UNITED STATES PATENT AND TRADEMARK OFFICE

10/550,384

Office Action Summary	Application No. 10/550,384	Applicant(s) VENSTRA, WARNER JURRIEN	
	Examiner WALTER H. SWANSON	Art Unit 2823

DETAILED ACTION

【図2】

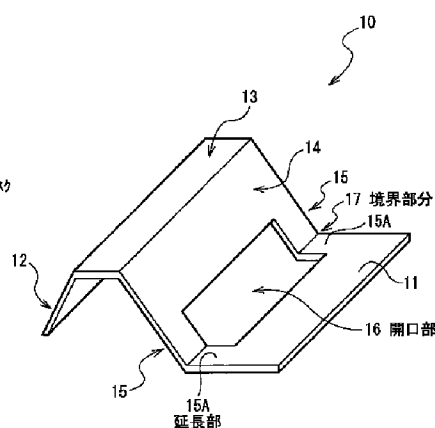
Hara discloses a method according to claim 1, wherein after the completion of the etching step, the masking layer is removed (FIG. 2).

Hara discloses a method according to claim 1, wherein said step comprises providing a longitudinal opening that extends through the membrane formed in the (111) plane, wherein the opening extends from the free end of the membrane into the direction of a position where the membrane is attached to the wafer (FIG. 2).

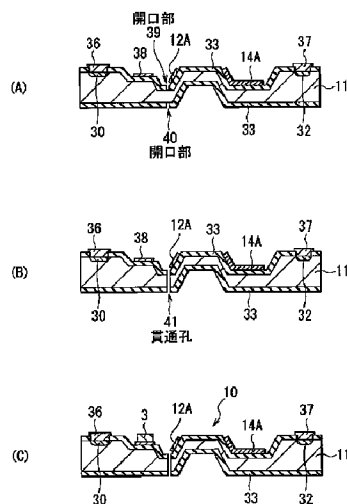
Hara discloses a method according to claim 1, wherein into both sides of the wafer V-shaped recesses are etched, wherein the lowest point in a V-shaped recess in a first side is positioned adjacent to a not covered portion at the other side of the wafer (FIG. 4(D)).

【図6】

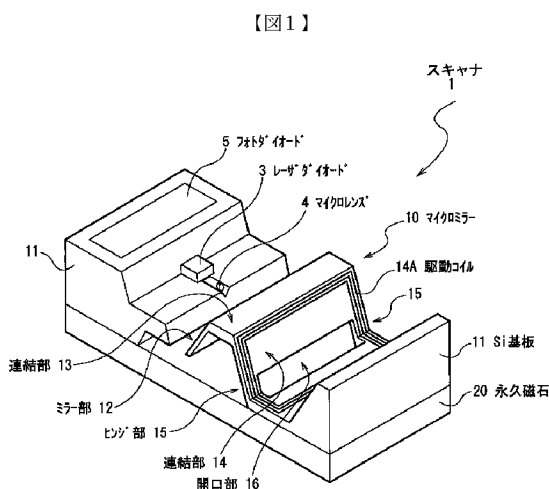
Hara discloses a method according to claim 1, wherein at least two parallel longitudinal openings are formed, oriented substantially perpendicular in relation to the line where the formed membrane is attached to the wafer, so as to form at least one cantilever (FIG. 6 (B)).

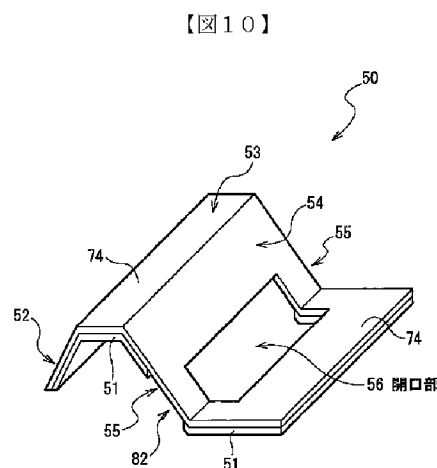
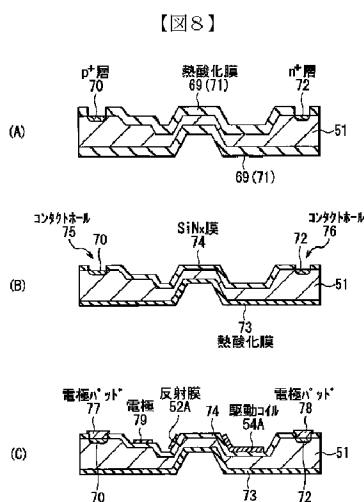
Another embodiment of Hara **teaches** applying a material (74) that exhibits a different etching behaviour than silicon onto the membrane (FIGS. 8(A)-(C), 10).

Another embodiment of Hara discloses a method according to claim 23, wherein the layer of the material is applied over at least a portion of the silicon membrane's surface (FIGS. 8(A)-(C), 10).

Another embodiment of Hara discloses a method according to claim 23, wherein the material forming the layer (74) is selected from silicon nitride, silicon oxide or silicon carbide (FIGS. 8(A)-(C), 10).
